## **ESTABLISHMENT OF A WIND ENERGY FACILITY SITUATED ON THE EASTERN PLATEAU (SOUTH) NEAR DE AAR, NORTHERN CAPE PROVINCE**

**APPLICATION FOR AMENDMENT OF THE ENVIRONMENTAL  
AUTHORISATION (EA), INCLUDING EXTENSION OF THE EA  
VALIDITY PERIOD**

### **PART 1 EA AMENDMENT APPLICATION: FINAL AMENDMENT MOTIVATION REPORT**

**DFFE Reference number: 12/12/20/2463/1/AM9**

**Figure 6: Latest proposed layout (proposed Final Layout Plan (January 2023)) (green icons), set against the originally assessed 103 turbines (yellow balloons) and assessed 61 turbine layout (white squares) included in the authorised Part 2 EA amendment in 2015 – 2016.**

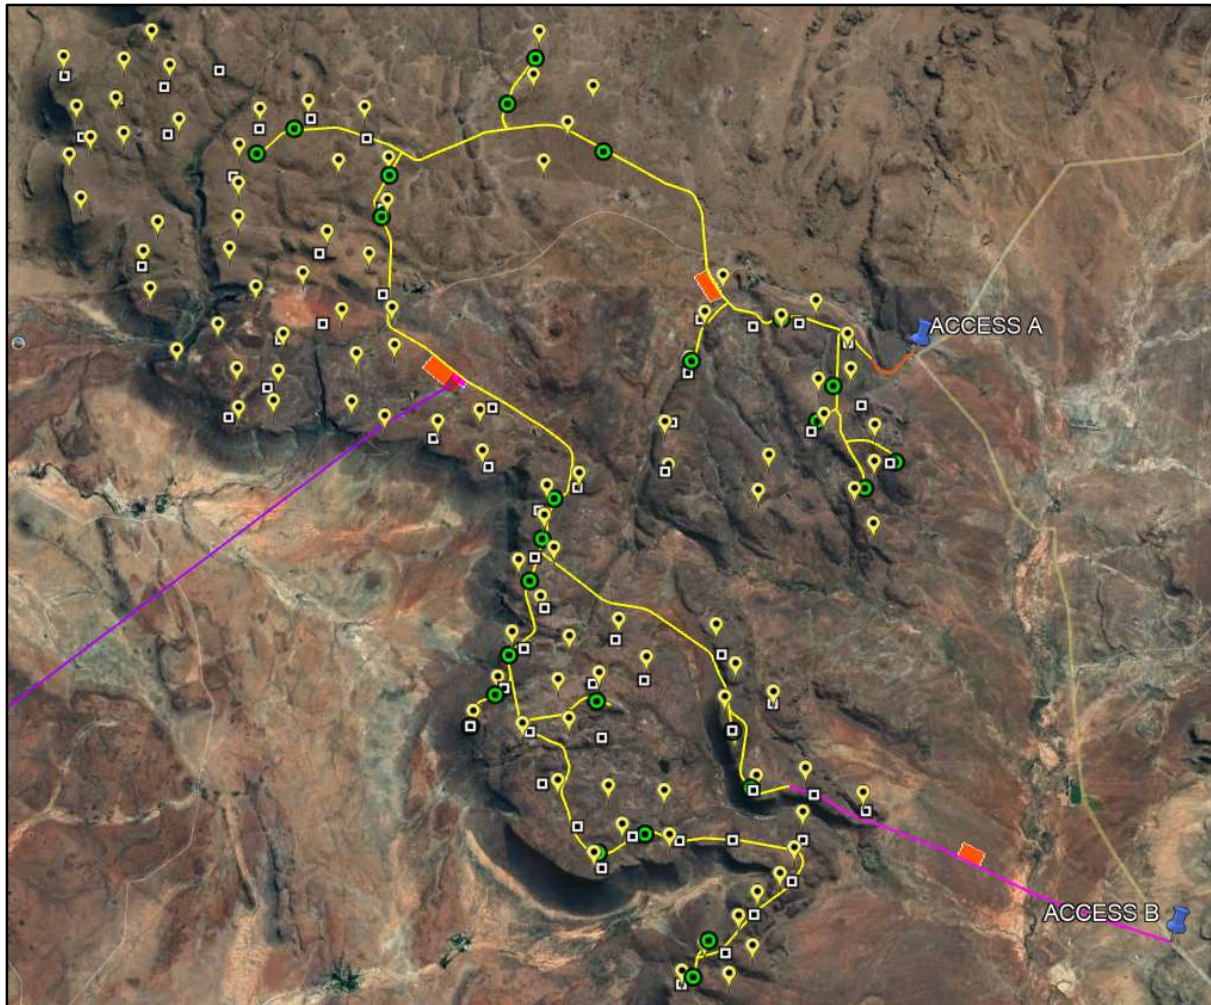
The current EA amendment application includes a reduction in the authorised number of turbines to be constructed to a maximum of 26 (down from a maximum of 61). The image below shows the latest proposed layout (green icons), set against the originally assessed 103 turbines (yellow balloons) and 61 turbine layout included in the authorized Part 2 EA amendment process in 2015 - 2016 (white squares). It can be seen that **the turbines are located in the same farms as originally assessed and within the same footprint area of the facility**. This provides evidence that the new (turbine) positions will remain within the assessed and authorised project footprint. Furthermore, all of the new proposed 26 positions have been assessed and recently checked (either through desktop analysis, but with additional site visit work by the majority of specialists) in the specialist “walk through”/EMP update reports as part of the layout finalisation process and micrositing.

**Figure 8: Section of proposed final road layout (yellow line) (showing a short section (approximately 260m) of access road, on Portion 7 of Farm 165).**

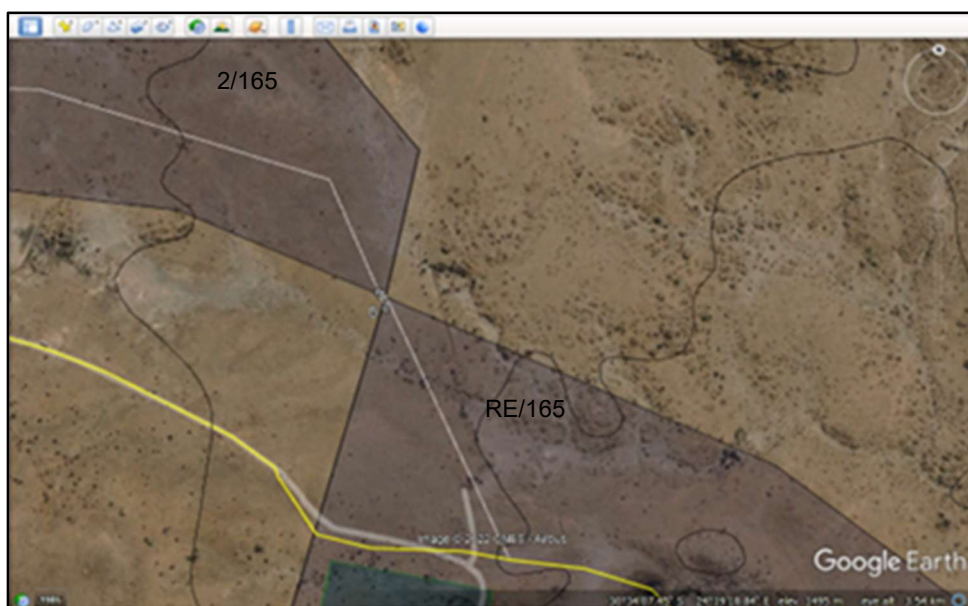
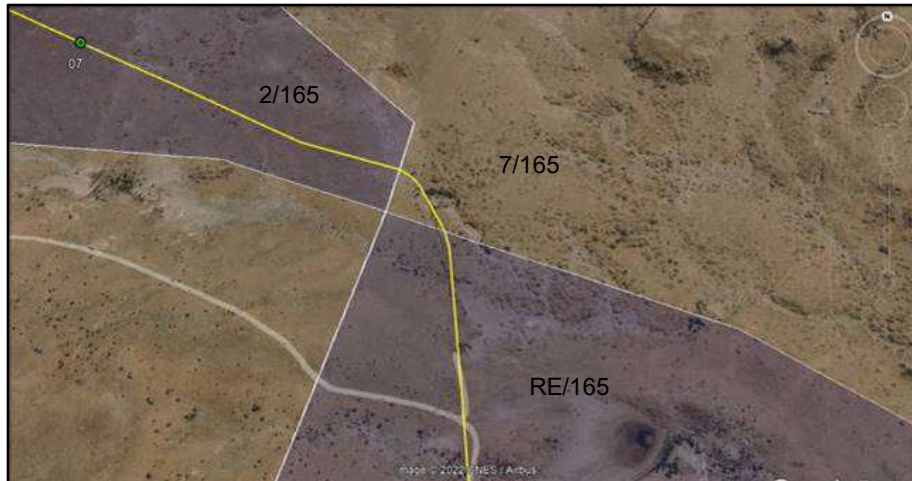
It became apparent to the Applicant during the finalisation of the Layout Plan for the project that there is a short section (approximately 260m) of a proposed internal access road that would cross a property (Portion 7 of Farm Vendussie Kuil No. 165) that was included in the combined Final EIA report (April 2012) for the De Aar 2 South WEF and De Aar 2 North WEF projects, and has been assessed by the specialists, however was erroneously not included in the Application Form and Environmental Authorisation (EA) for the De Aar 2 South WEF project. In this regard, as the holder of the EA progressed with the final design, they discovered that it is not technically feasible for the subject section of road to cross on a corner where four properties meet (refer to Figure 7 below which shows two properties shaded that are included in the EA). Therefore, the road needs to extend into the property to the north east (i.e. on Portion 7 of Farm No. 165) (as illustrated in Figure 8 below). Portion 7 of Farm No. 165 was included in the original EIA for the project (which was a combined EIA process and combined EIA report for the De Aar 2 North WEF and De Aar 2 South WEF), and whilst Portion 7 of Farm No 165 was included in the EA for the De Aar 2 North WEF project (which is now constructed and operational), it should also have been included in the EA for the De Aar 2 South WEF.

In light of the above, the Applicant would like to request for Portion 7 of Farm Vendussie Kuil No. 165 to be added into the EA for the project, given that it was included in the EIA process for the project **(and has been assessed again by the specialists during the recent EMPr and Layout Plan finalisation process in 2022)**, but was erroneously not included in the EA for the project.
